RE: **PETITION NO. 1230** – Eversource Energy petition for a declaratory ruling that no Certificate of Environmental Compatibility and Public Need is required for the proposed modifications to its existing Stony Hill Substation including the installation of a new access road to the substation on Eversource's property located at 49 Stony Hill Road, Brookfield, Connecticut.

Petition No. 1230

Stony Hill Substation, Brookfield, Connecticut

Staff Report

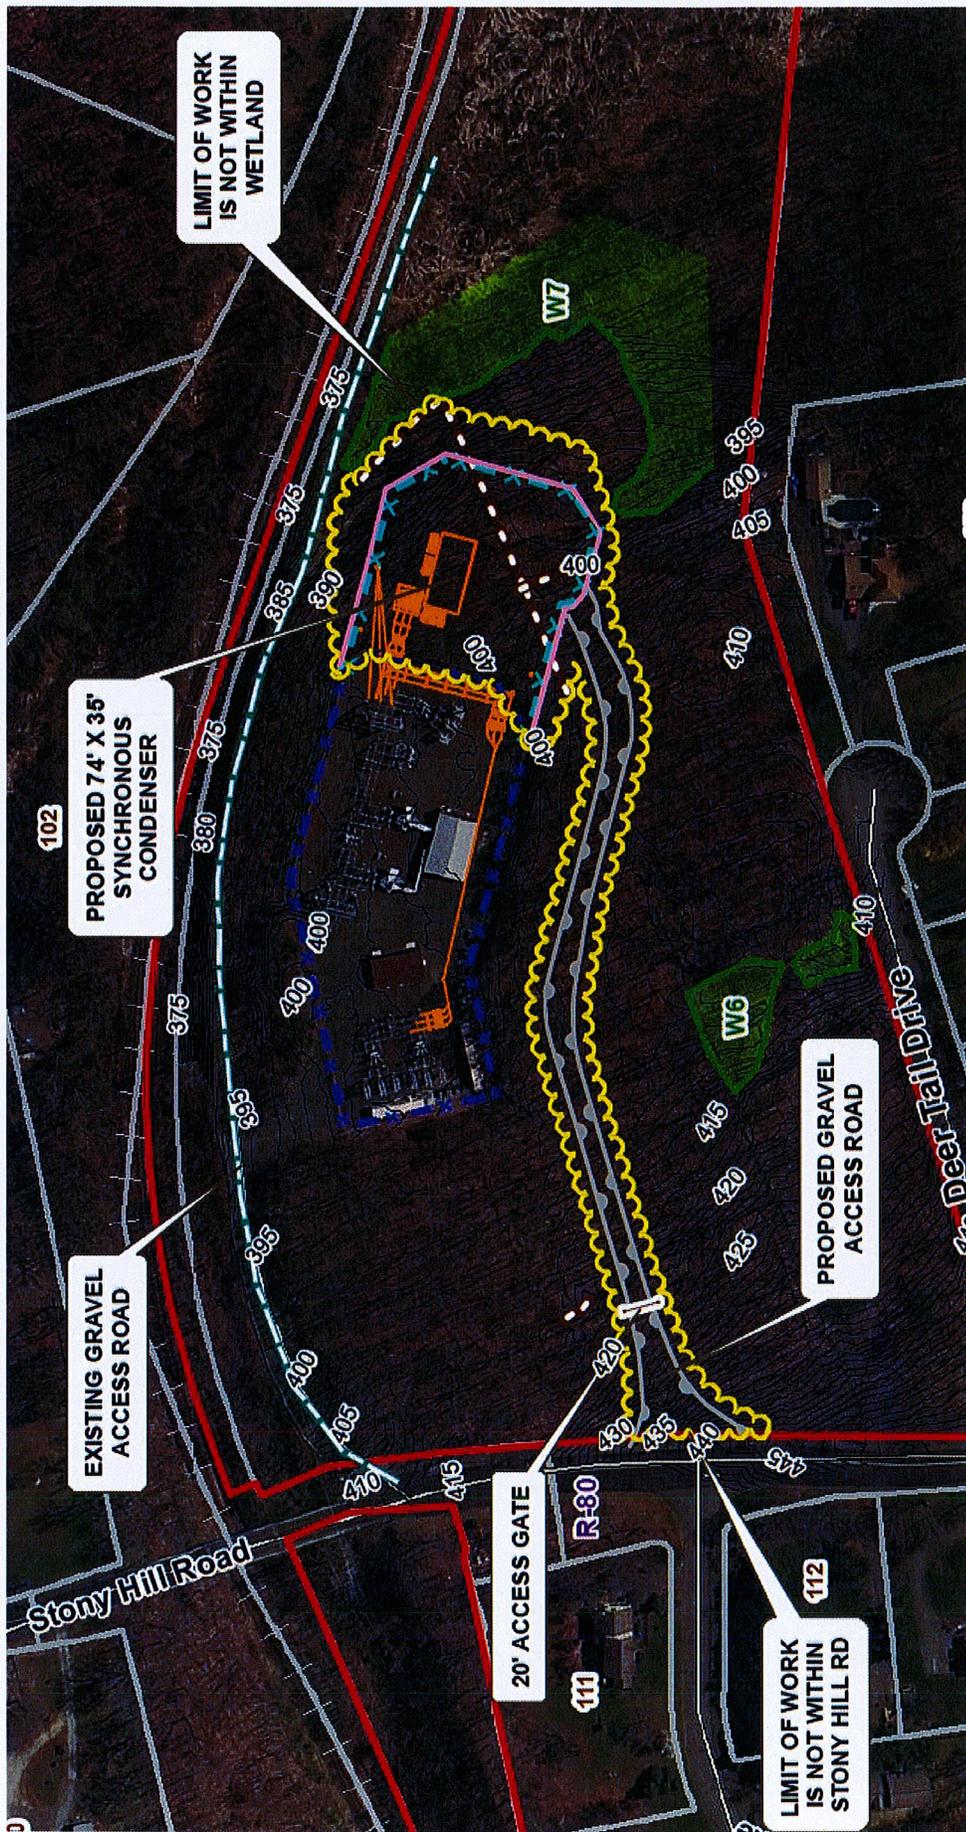
Two wetland areas were delineated on Eversource's property. One wetland (W7) is a forested and emergent wetland located immediately east of the proposed substation expansion area. After the initial filing, Eversource slightly modified the substation fence line to increase the distance to W7 to the greatest extent possible (21 feet). The second wetland (W6) is a small forested wetland approximately 150 feet south of the proposed access drive.

The ground elevation in the substation expansion area decreases by approximately 14 feet from the southwest corner to the northeast corner. Eversource would need to import fill to create a level surface and create an armored slope along the north and east sides, adjacent to the wetland. The access road traverses uneven, rocky terrain and would require cut and fill to create a level, graded surface. Excavated rock and old stonewalls in the path of the access drive could be used for the necessary slope armoring along the road or in the substation expansion area.

A Town maintained stormwater catch basin exists along Stony Hill Road in the area of the new access road apron. It appears this catch basin discharges on Eversource's property approximately 20 feet north of the catch basin. The outfall is elevated, causing scouring and drainage channelization on Eversource's property. Eversource would have to examine this outfall, in coordination with the Town, to prevent the proposed access road from being undermined by this existing drainage pattern.

1. Examine the feasibility of extending the new access drive from Deer Tail Drive;
2. Submit a final site plan detailing road and substation clearing limits, contours, grading, drainage control and E&S controls, for Council review and approval;
3. Use of on-site material for side-slope armoring, if feasible;
4. Identification of Project construction work hours; and approval of any minor project changes be delegated to Council staff.
